P20 & P20-DS

V1.6.0

Release Notes

1.3.1 Audio Matrix (P20-DS)

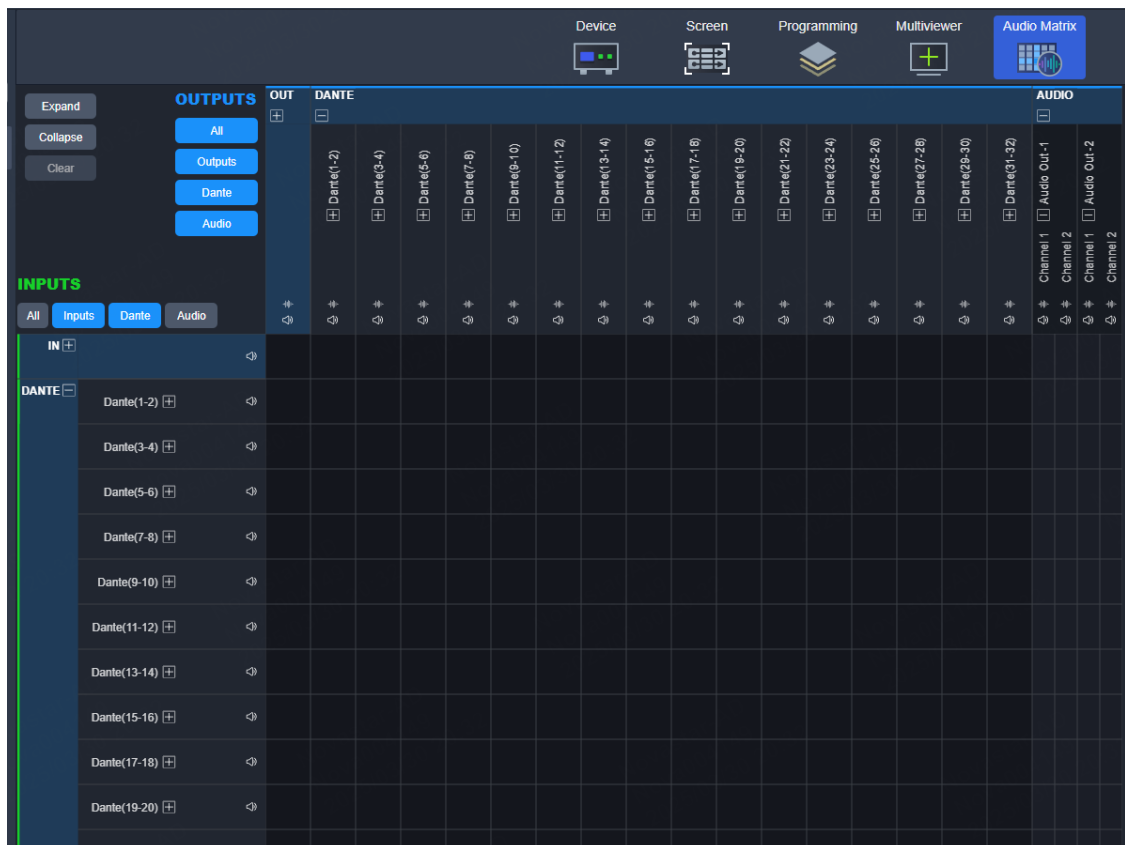
Allows users to manage audio inputs and outputs and map audio channels.

V1.6.0 of switchers introduces an audio matrix feature. By clicking the **Audio Matrix** tab at the top of the homepage of PixelFlow, users can access the **Audio Matrix** tab page.

The top left corner of the page is the quick actions panel. The list on the left displays the inputs, where you can view input channel names and channel audio status, and mute the channels. The list at the top displays the outputs, where you can view the output channel names, play the test sound, and mute the channels. Click an input/output to expand or collapse the list.

1.3.4 LCD Screensaver

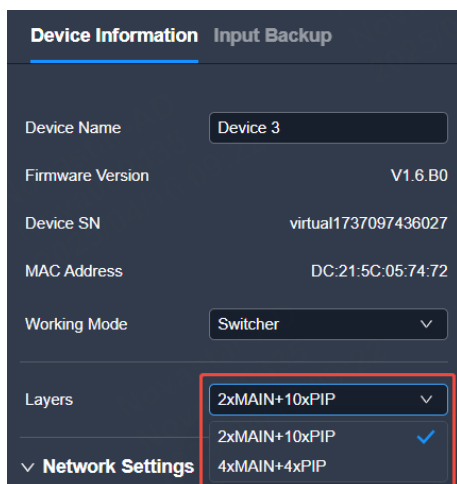
Prolonged display of a static image on the LCD screen may cause screen burn-in. Using a screensaver can effectively protect the screen.

- When the LCD remains inactive for more than one minute, a screensaver will appear.
- The screensaver will be displayed over the current screen, without redirecting to the home screen.
- To exit the screensaver, press any button on the front panel.
- Icons within the screensaver will move along a set path at a consistent frequency.

1.3.5 Layer Mode Switching

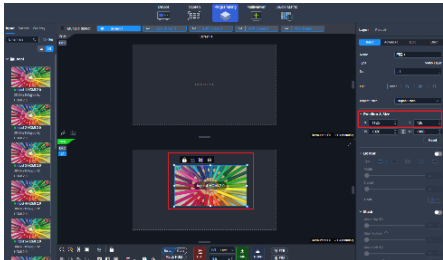
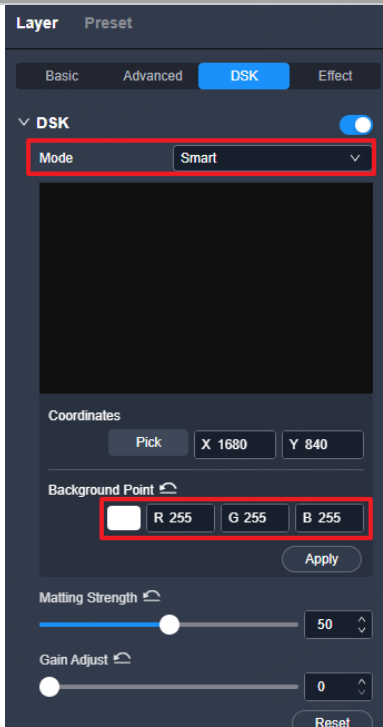
Offers users a variety of options, allowing them to switch between two layer modes according to their preferences.

On the **Device Information** tab page, users can switch between **2×MAIN+10×PIP** and **4×MAIN+4×PIP** layer modes.

1.5 Improvements

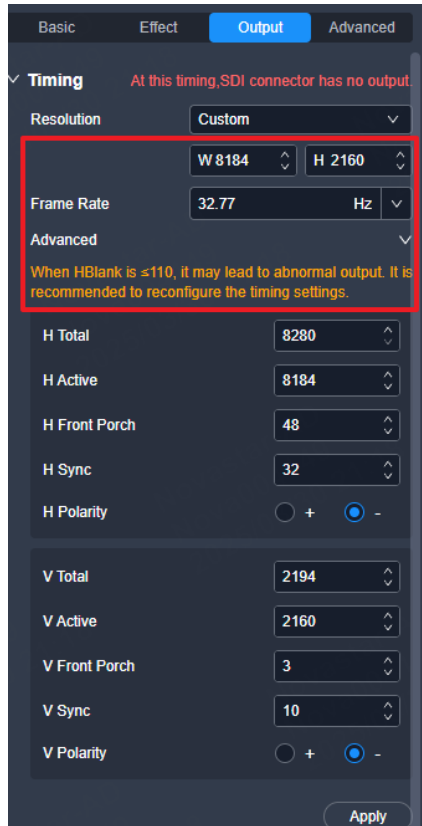
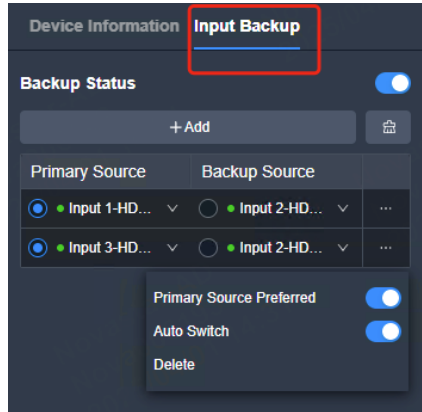
Improvement	Before	After
Layer repositioning by keyboard shortcuts	Layers can be repositioned only by dragging them or entering the coordinates.	After selecting a layer, you can move it in one-pixel increments using the keyboard arrow keys. By using Shift along with the arrow keys, the layer will move in increments of ten pixels. Holding the keys allows for continuous movement. 
Capable of keying out white background	DSK in smart mode does not allow white background to be keyed out.	DSK in smart mode allows white background to be keyed out.
